Subject: Correction to Annual Radiological Environmental Operating Report – 2003
Originally Submitted via Letter WF3-2004-0026
Waterford Steam Electric Station, Unit 3 (Waterford 3)
Docket No. 50-382
License No. NPF-38

Correction to Annual Radiological Environmental Operating Report - 2003

**Annual
Radiological Environmental Operating
Report**

**Waterford 3 Steam Electric Station
Entergy Operations, Inc.**

FIGURE 1-1

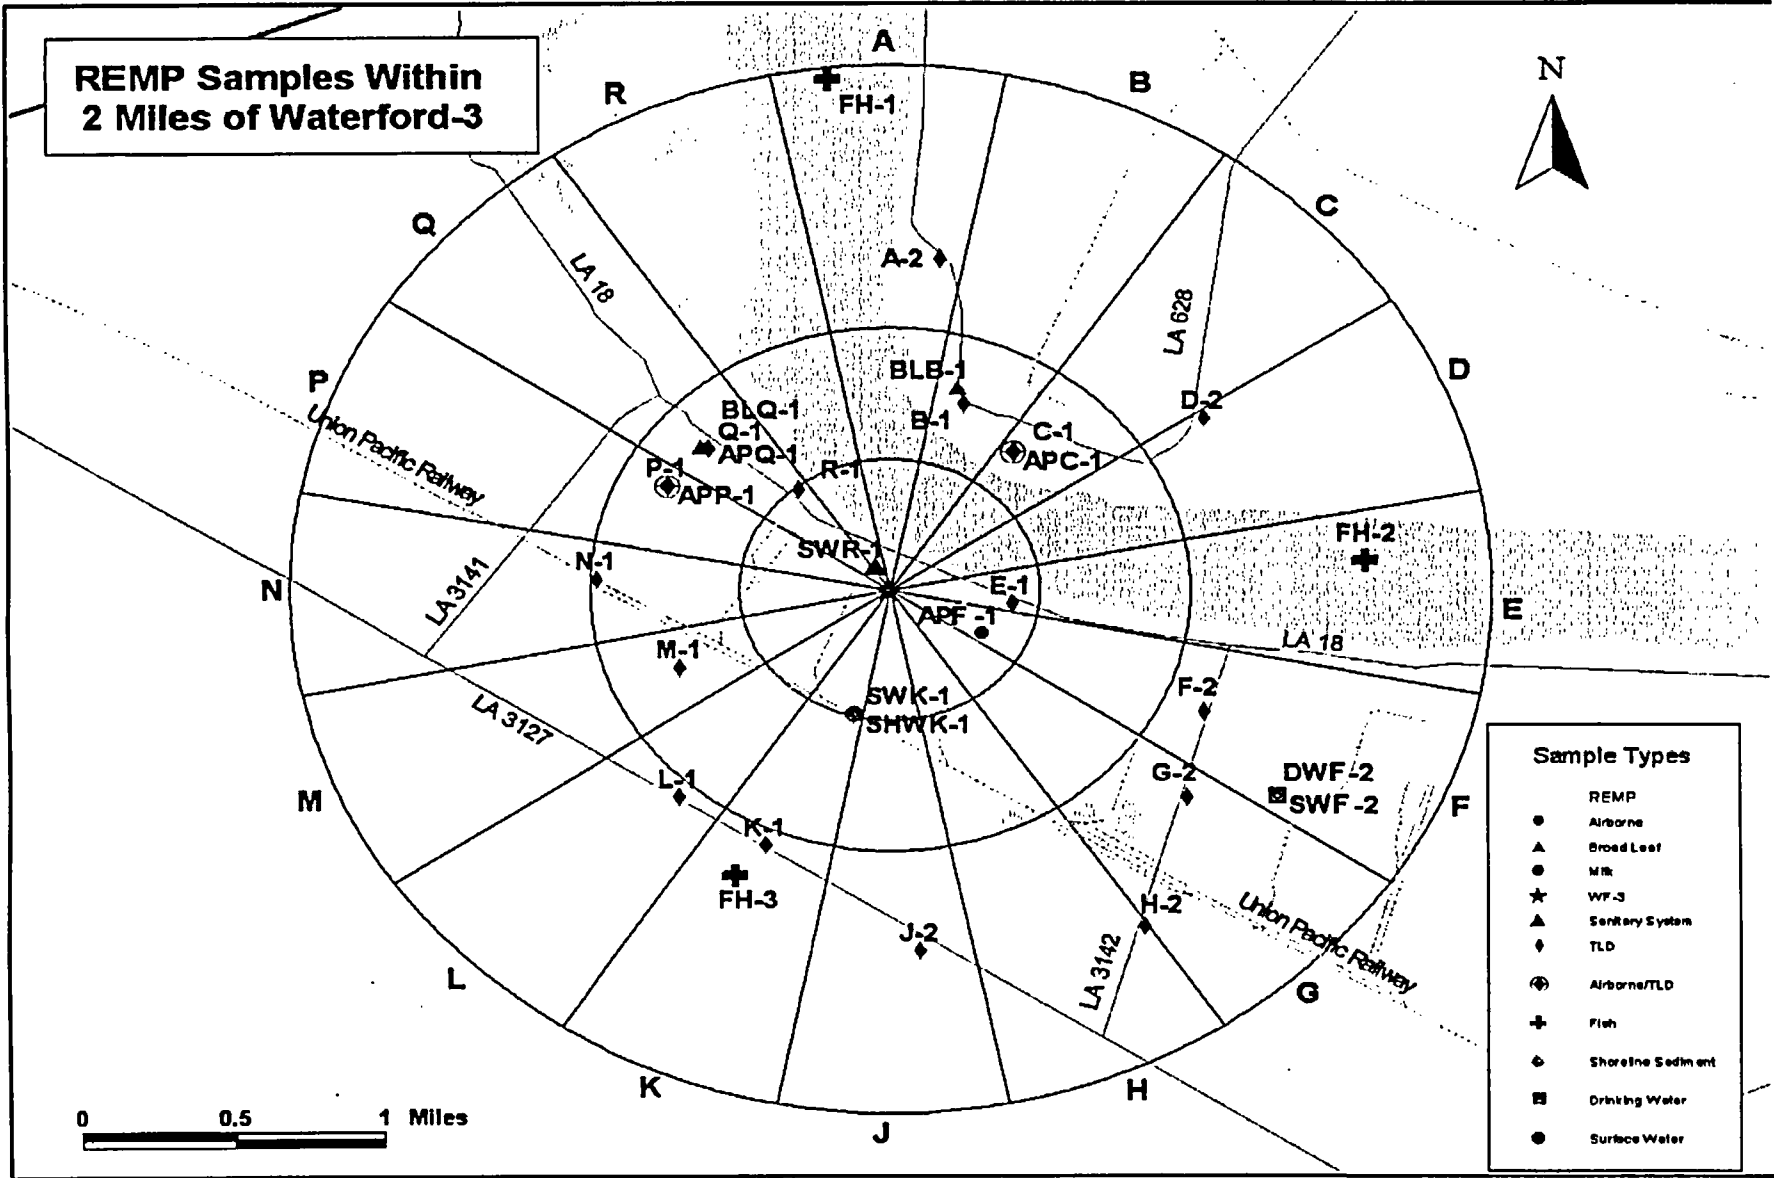
1. Figure 1-1, page 17: Changed APG-1 to APF-1
Changed DWG-2 to DWF-2
Changed SWG-2 to SWF-2

Although data points throughout the report are correct, the map in figure 1-1 was not updated to reflect the changes from sector G to F.
